## MEMORANDUM

Date: May 3, 2024  
To: Dale Puskas, P.Eng., District of Central Saanich  
Cc: Kelsey Tyerman, Starlight Developments  
From: Noah Reeder, EIT and Andy Kading, P.Eng., P.E., WATT Consulting Group  
Our File No: 3734.B01  
Subject: 7840 Lochside Drive - TIA Addendum

A proposed conceptual design is shown in **Figure 2**.

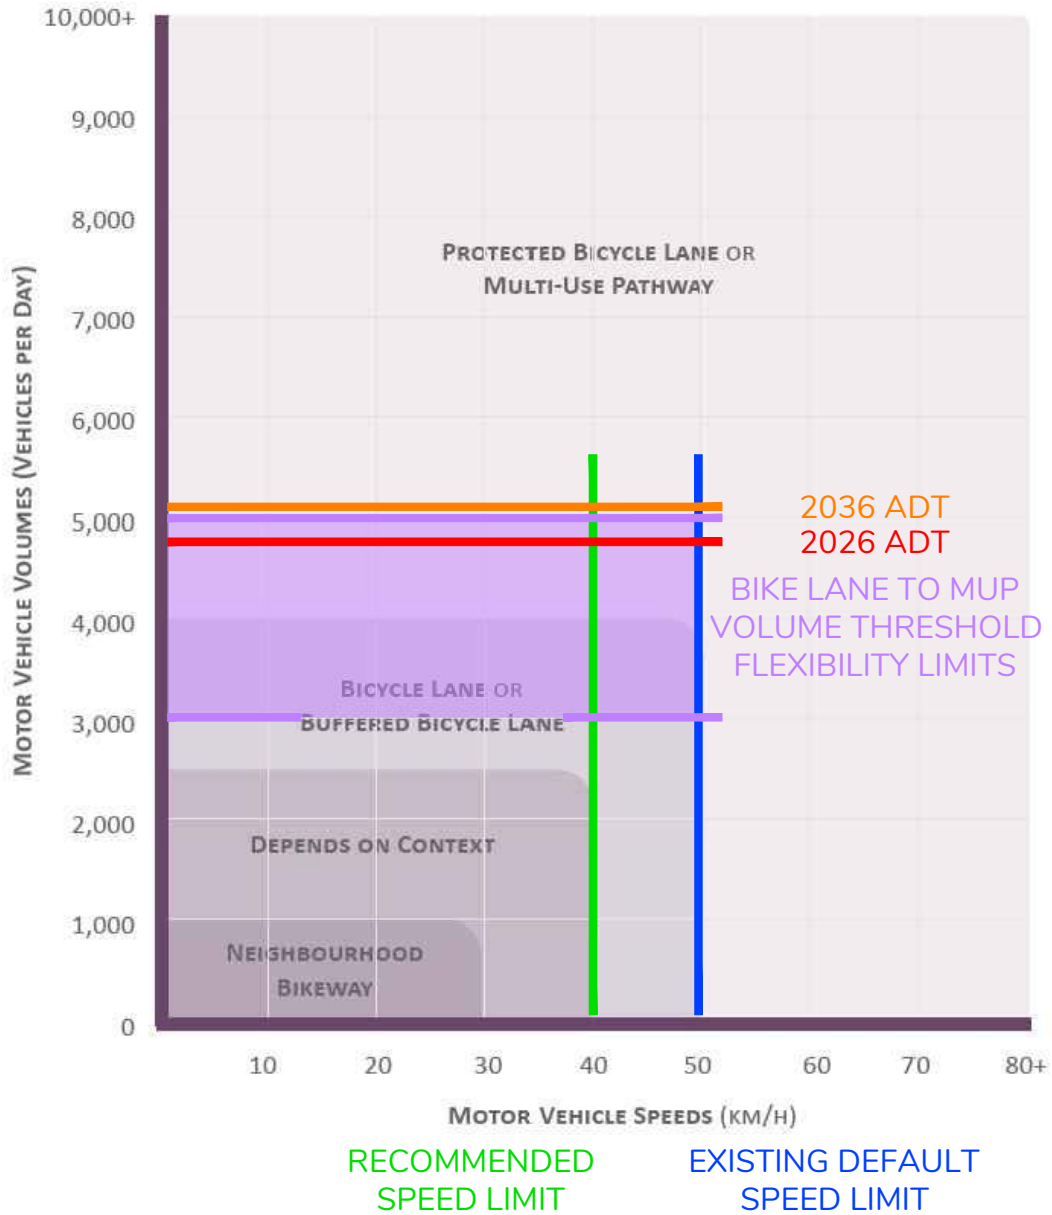
The precise location for this proposed crosswalk was chosen to minimize loss of on-street parking, align with existing street lighting, and to ensure the necessary stopping prohibitions are accounted for. Without a curb extension on the west side, southbound stopping prohibitions would need to be introduced at least 15 m before and 10 m after the crosswalk to ensure vehicles in the parking lane do not obstruct the visibility of pedestrians about to enter the crosswalk. This would result in an overall loss of five (5) on-street parking spaces. A curb extension would provide better pedestrian visibility and, when implemented with TAC's minimum recommended curb radii and a crosswalk width of 3.0 m, would require removal of only two (2) southbound on-street parking spaces.

The RRFB crosswalk should feature the following:

- RRFBs and side-mounted signs (PS-003-L/R) mounted back-to-back on each side of Lochside Drive for northbound and southbound traffic, for a total of four (4) signs and four (4) RRFBs on two (2) poles.
- Zebra crosswalk markings
- Pedestrian pushbutton with sign (PS-015-D) on each side
- A curb extension into the parking lane on the west side of Lochside Drive
- Northbound stopping prohibition for a minimum of 10 m north of the crosswalk
- TAC also recommends a northbound stopping prohibition 15 m south of the crosswalk; however, this distance is entirely within the Lochside Drive / Ferguson Road intersection where vehicles are already prohibited from stopping.

Optionally, the following improvements may be made to the northeast corner of the intersection, shown in order of importance:

1. Add a curb letdown facing the crosswalk to ensure accessibility for pedestrians with disabilities and other users.
2. Reduce the corner radius to the TAC recommended range of 3.0 to 5.0 m. TAC recommends smaller corner radii to reduce crossing distance and encourage lower speeds for right-turning vehicles. This corner currently has a radius of approximately 8.6 m.
3. Pave the existing gravel sidewalk from the corner to the bus stop north of the intersection, a distance of 18 m. This will improve accessibility and make the bus stop more appealing to all users.

WATT recommends that a crosswalk with side-mounted signs and RRFBs mounted back-to-back be implemented on the north leg of the Lochside Drive / Ferguson Road intersection with an extension of the west curb into the existing parking lane.

- Side-mounted signs (PS-003-L/R) and RRFBs mounted back-to-back on each side of Lochside Drive for northbound and southbound traffic for a total of four (4) signs and four (4) RRFBs
- Pedestrian pushbutton with sign (PS-015-D) on each side, for a total of two (2) pushbuttons and two (2) PS-015-D signs
- Zebra crosswalk markings
- Northbound stopping prohibition for a minimum of 10 m north of the crosswalk
